**WORKS ON MERTON PRIORY WALLS AT ABBEY WALL WORKS**  
**A response by Wandle Valley Forum to planning application 21/P1069**  
**July 2021**

Fig.7: Plan of the proposed evaluation trenches, based on an existing site survey

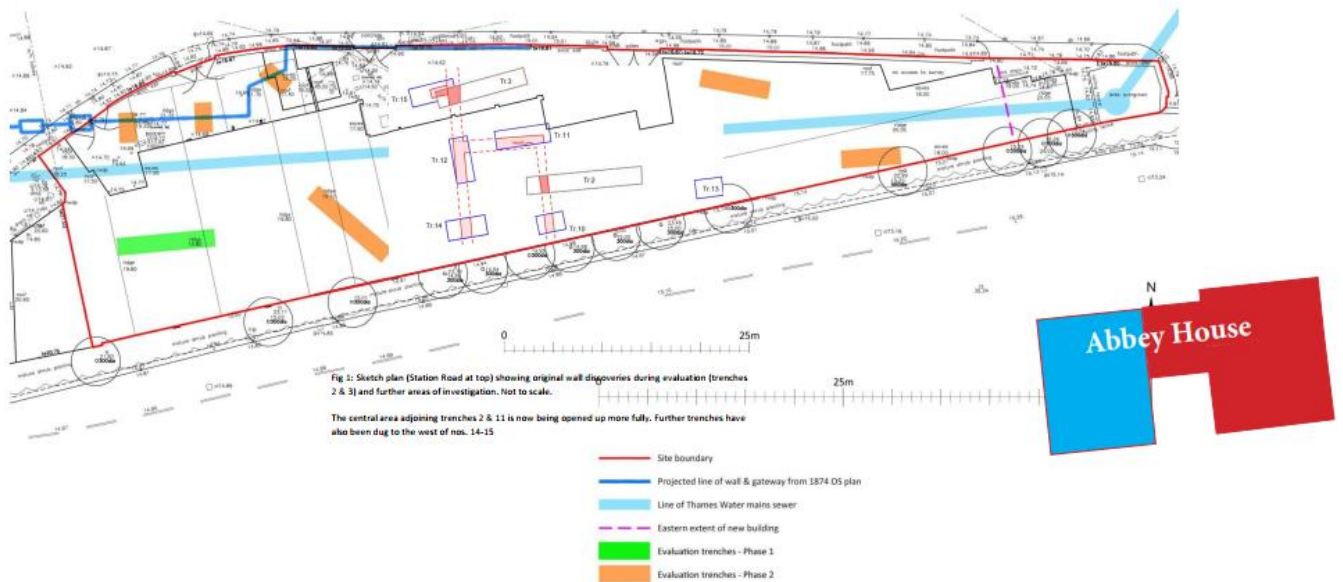
1. Wandle Valley Forum provides support and an independent voice for 140 community groups, voluntary organisations and local businesses and for everyone who shares a passion for the Wandle.
2. We have considered the proposals to demolish and rebuild two sections of the Grade II listed wall that form part of the boundary of the consented Abbey Wall Works development. We are content that the poor state of the existing walls means that a sensitive demolition and rebuild is a sensible option. Any historic material revealed through the process should be re-used in the structure.
3. It is essential that any works are preceded by detailed archaeological investigation. The westernmost section (red line) appears to be directly over the eastern gate post (blue line) shown on the 1874 OS map as evidenced by this excavation plan:
